Service Information

M51 04 15

Delivery Stop: Side Impact Performance

F56 (Cooper Hardtop 2 door)

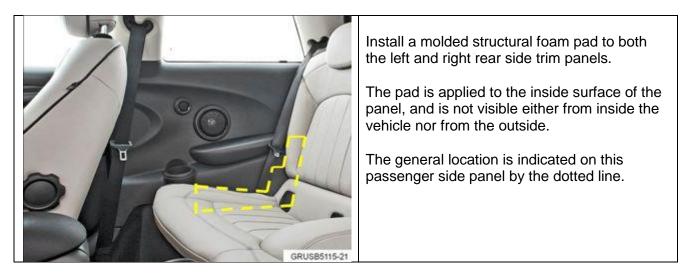
The vehicle's side structure is designed to help absorb energy in the event of a side collision. Due to vehicle build variation, some of the vehicles may marginally exceed a NHTSA test requirement. MINI is performing a voluntary upgrade to these vehicles. Additional energy-absorbing material between the rear interior side panels and the vehicle structure will be added to help enhance occupant protection in the event of a side collision.

Refer to Attachment 2 to modify the side panel and install the structural foam pad.
